**Bulletin**

MODEL : BENTLEY MARK VI

EXCESSIVE LEAKAGE OF OIL AT THE CENTRE STEERINGLEVER AND STUB AXLES(CENTRALISED CHASSIS LUBRICATION SYSTEM).FOR INFORMATION:

FOR CATEGORY 2 ACTION:MODIFICATIONSIDE STEERING TUBE - FRONT END SOCKET.

Fig. 1. Section through ball joint at front end of side steering tube.

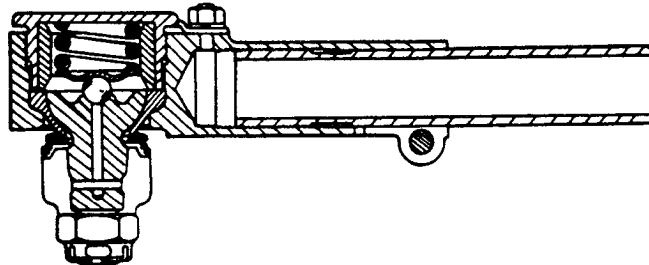
When the pedal of the chassis oil pump is operated, a relatively large quantity of air is trapped in the three ball joints connected to the centre steering lever and compressed. During the next few hours, the trapped air expands, pushing the oil along until it escapes past the fulcrum pin bearings of the centre steering lever pivot assembly and the bearings of the stub axles.

The cure lies in packing the four joints of the cross steering tubes and the ball joint at the front end of the side steering tube with a soft type of grease such as Duckham's HBB grease in order to displace the air.

- (i ) Remove the front right-hand undershield. Jack up front wheels and turn wheels to full right-hand lock.
- (ii ) Remove split pin and nut from ball pin.
- (iii) Place a substantial steady block in contact with the lever near the ball pin to be removed, in order to provide a solid re-action point, and then with the aid of a large steel drift and hammer, give the eye of the lever (adjacent to the ball pin) one or more sharp blows which will release the tapered shank of the pin from its location in the lever. NOTE: The above method applies to all the ball joints to be removed.
- (iv ) Collect the pressure spring and the sealing disc.
- (v ) Remove the cap nut of the joint (see Fig.1) and completely pack the joint with grease.

- (vi) Before refitting the ball joint (ball pin) to the lever, clean the tapered shank of the pin and corresponding hole. With the sealing disc and pressure spring in position on the pin and the correct way round (See Fig. 1), refit the ball pin to the lever, fully tighten up the nut and secure with a new split pin of the correct size.

Fig. 2. Section through a ball joint (outer) of a cross steering tube.

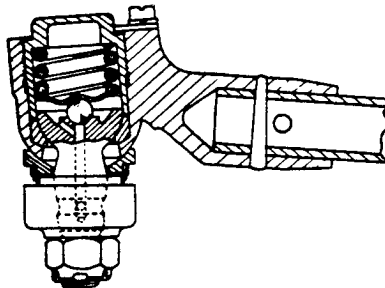
NOTE: Do not use a hammer when refitting the ball pin to the lever, but rely on tightening the nut to draw the mating parts together. Treat the four ball joints of the cross steering tubes in a similar manner. Fig. 2 shows a section through a ball joint (outer) of a cross steering tube. Finally inspect that no split pins, locking plates and spring washers have been omitted.

FIG. 1.

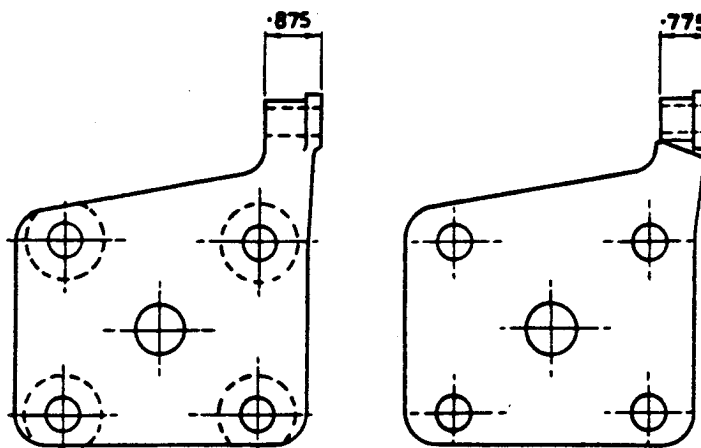
Retailers are advised that a new type of strengthened rear spring plate for the shock damper linkage attachment has been introduced on current models in production. This supersedes the earlier designs fitted and is now the only replacement available.

The new plate (Fig.1) is similar in general shape to the earlier designs, but no machining has been carried out on either face beyond the spot facing on the underside of the 'U' bolt holes. Owing to this, left-hand and right-hand plates are now required as follows:-

An intermediate type of modified spring plate, RF-8101 (Fig.2) was used for a short period prior to the introduction of the latest design, but this has proved unsatisfactory in service. In view of this, it has been decided to request Retailers to modify all cars in their areas fitted with this intermediate type plate on a Category 1 basis.

It should be noted, that due to the increased width of the boss on the new type plate (0.875" as against 0.775" on the earlier design) new anchorage pins for the lower shock damper linkage will also be required when these new plates are fitted. These pins are supplied separately, and should be assembled in their respective plates prior to these being fitted to the car.

- RF-8537..... Rear Spring Plate, R.H.
- RF-8538..... Rear Spring Plate, L.H.

RF-8537	Lower Rear Spring Plate - R.H.	1 Off.
RF-8538	" " " " - L.H.	1 Off.
RF-8256	Pin - Lower Silent Block Bracket-Damper	2 Off.
K -4322	Lock nut.	2 Off.

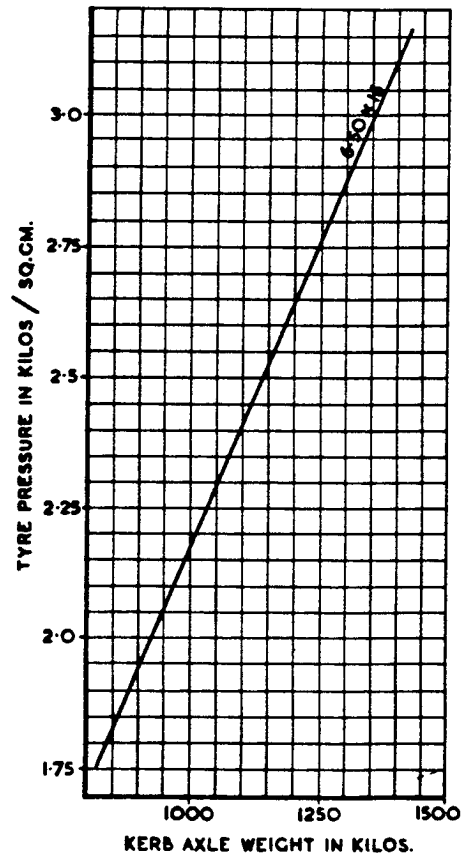
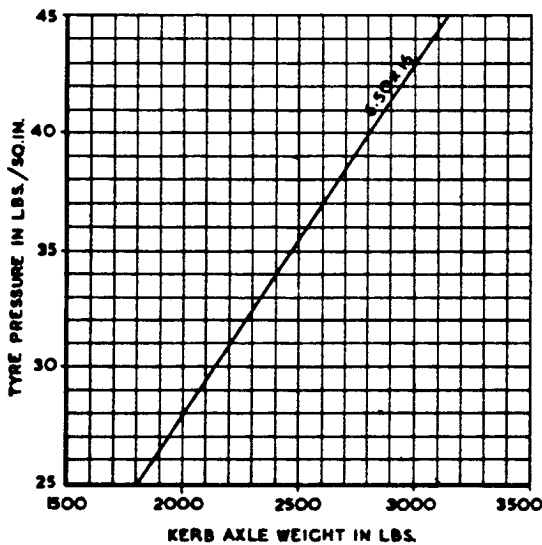
The weight on the front wheels is unlikely to vary sufficiently to warrant any alteration in the recommended front tyre pressures, but the rear axle weight on certain cars may necessitate an increase in the rear tyre pressures.

The following chart shows the recommended rear tyre pressures for a given unladen rear axle weight. (This weight is the kerbside weight, i.e. full tank but no passengers).

Certain cars which have a lot of overhang at the rear, but are not necessarily heavy, will steer better if the rear tyre pressures are increased a few pounds.

Front - 23 lbs.sq.in. (1.65 Kg/CM<sup>2</sup>)  
 Rear - 30 lbs.sq.in. (2.15 Kg/CM<sup>2</sup>)

FIG.1. SECTION - BALL JOINT-SIDE STEERING TUBE REAR END.

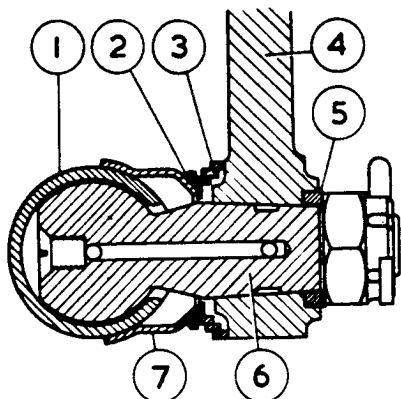
a) Remove the castle nut and the locating washer, 5 Fig.1 from the ball end pin(6), then give the bottom of the pendulum lever (4) a sharp tap upwards, i.e. at right-angles to the axis of the ball pin. This should release the pin. A large steady block should be held against the upper end of the lever to absorb the shock, and a drift used on the lower end to prevent damage to adjacent parts.

**NOTE:** When re-connecting the side steering tube to the pendulum lever, it is important that the mud excluder (7 Fig.1) is placed the correct way round, i.e. with the longest plain portion pointing

towards the rear end of the tube. After placing the ball pin in the pendulum lever, make sure that the flats and lugs of the locating washer (5 Fig.1) correctly engage with the corresponding flats and slots on the ball pin and in the lever.

If it was found necessary to remove the slotted end-nut, rear ball pad and the spring and guide assembly from the rear end of the side steering tube then prior to placing the ball pin in the pendulum lever measure the length of the coil spring and if it has a free length of 0.875" (22.2 m/m) the adjustment of the rear end of the side steering tube is as follows:-

Screw in the slotted end-nut, until the ball pads, spring and guide assemblies are choc-a-bloc. Slacken the end-nut back 0.100" (2.5 m/m) in order to restore the original working clearance of 0.050" (1.27 m/m) between the end of each stem of the ball pads, and the inner end of the tube and the inner face of the end-nut. In all cases the end-nut must be secured by a new split pin. Part No. K.4616/Z.

FIG.2. SECTION-SOCKET-SIDE STEERING TUBE FRONT END (PRIOR TO MODIFICATION.)

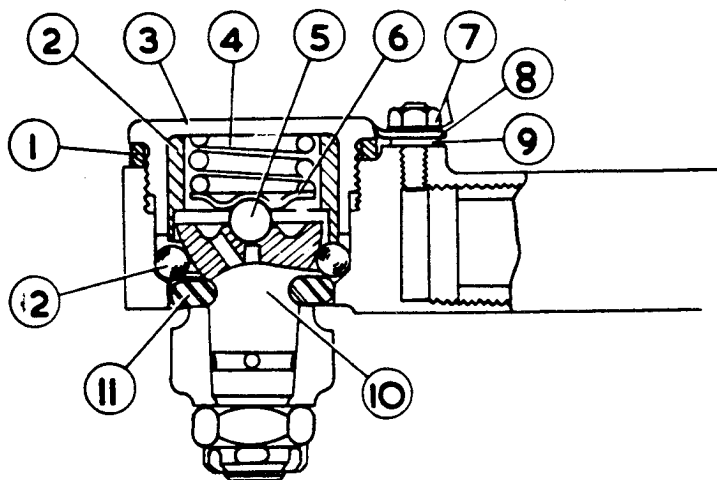
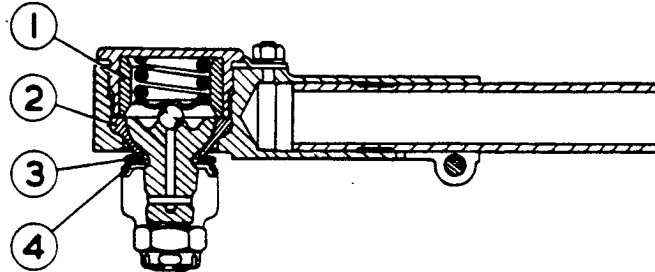
Commencing at Chassis No.B-215-PU steel balls (12 Fig.2) were incorporated in place of the previous bronze seat (2 Fig.3) in the front end socket of the side steering tube to reduce steering friction.

Owing to the steel balls grooving and causing hard steering, these have been discarded and reversion has been made to the original bronze seat as from Chassis No.B-390-TN and onwards on right-hand and left-hand drive cars.

This modification is therefore introduced to modify Chassis Nos.B-215-PU to B-388-TN (inclusive) to revert to the previous arrangement.

**NOTE:** When it is found that the ball end pin (10 Fig.2) of the front socket has been grooved or pitted by the steel balls, a new pin FW-1000 (included in the list of parts on Page 1) should be fitted.

1. Sleeve - front socket. (RF-3561)
2. Bronze seat - front socket. (FW-996)
3. Sealing disc - mud excluder - front socket. (RF-3563)
4. Pressure spring - sealing disc - front socket. (FW-403)

- (i) Remove the rubber seal (11 Fig.2) from the groove in the ball pin.
- (ii) Remove the nut and spring washer, (7), the locking plate (8), the plain washer (9), and with a 'C' spanner, remove the cap nut (3).
- (iii) Remove the joint ring (1) from the cap nut, the sleeve (2), the spring (4), the spring pad (6), the ball (5), the ball pin (10), and finally the steel balls (12). Items 1, 2, 9, 11 and 12, should be discarded. The sleeve (2) is replaced by the sleeve RF-3561. Clean the remaining dismantled parts.
- (iv) Re-assemble the ball joint, using the new parts as illustrated in Fig.3, and refit to the centre steering lever.
